PLANNING AND ZONING COMMISSION MEETING AGENDA

REPORT SUMMARY				
Agenda Item:	New Business #1	Project Number:	PZ-22-00451	
Project Name:	Maverik Subdivision – Sketch Pla	t Presentation		
Project Location:	29.9 acres north of Foothill Blvd.			
Project Description:	Sketch plat presentation of a new	w commercial sub	division.	
Applicant:	Todd Meyers Maverik 185 South State Street, Ste 800 Salt Lake City, UT 84111	Property Owner:	Express Development LLC 1524 Eubank Blvd NE Ste 5 Alberquerque, NM 87112	
Engineer:	Daniel Kennedy JFC Engineers & Surveyors 1682 Sunset Drive Rock Springs, WY 82901	Surveyor:	Kent Felderman JFC Engineers & Surveyors 1682 Sunset Drive Rock Springs, WY 82901	
Public Notification:	N/A			
Current Master Plan Land Use Designation:	HDR (High Density Residential) I (Industrial)	Proposed Master Plan Land Use Designation:	No proposed change	
Current Zoning District	I-1 (Light Industrial)	Proposed Zoning District	No proposed change

References:	Rock Springs Zoning Ordinance §13-810 Light Industrial Zone Rock Springs Subdivision Ordinance §16-501 Sketch Plat Rock Springs Subdivision Ordinance §16-507 Approval of Minor Subdivisions			
Exhibits:	A. Maverik Subdivision Sk

SKETCH PLAT

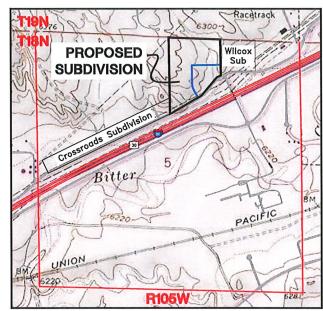
Comment Sheet by 5: I Meghan Jackso (Dept./Organization) for	or the above-referenced project.	hank you! If of Engineering Dept			
Email: megnan_ja	ackson@rswy.net Phone #	307-352-1540			
Revisions require 1. All roads within the su Other Comments	approved as submitted. ed to the Site Plan/Plat/Drawing (attach separate shibdivision shall be private. //Issues (attach separate sheet if necessary): ge, grading, and geotechincal report; as well a				
☐ Please provide r	ne with a copy of the Revised Plans for review.				
Mit		11/16/2022			
Signature of Review	er	Date

Comment Sheet by 5 I Christy Austin	for the above-referenced project.	the plans on behalf	
Please check as applic			
	s approved as submitted. red to the Site Plan/Plat/Drawing (a	ittach separate she	eet if necessary):
We may need to a	s/Issues (attach separate sheet if ne address the easements. If i can' y need to extend it outside Lot 1	t get the reroute	, with anchoring, inside the
☐ Please provide	me with a copy of the Revised Pl	ans for review.	
Control of the state of the sta	Digitally signed by Christy Austin Date: 2022.11.15 14:49:38 -07'00'		11/15/2022
Signature of Review	ver	<u>I</u>	Date

Comment Sheet by 5 I Darin Kaufman (Dept./Organization) f Email: darin.kaufma Please check as applic No issues - plans	(name) have reviewed the plans or the above-referenced project.	on behalf of <u>WYDOT</u> Phone #: <u>307.352.3034</u>			
Other Comments	s/Issues (attach separate sheet if necessary):				
It appears the pro WYDOT's Access roadways (Foothil location, access s the applicant prop spacing requirement applicable to the e	posed Access Easement location looking Manual requirement of no access within I/Interchange). However, looking west pacing (1320') to the next access (Cumboses roadway improvements for Foothing the state along Foothill may be reduced east to the two intersecting state roadways.	ng east along Foothill Blvd meets n 660' of two intersecting state of the proposed Access Easement berland) is not met. It is anticipated if ll and surrounding area, the access. This access spacing reduction is not ays.
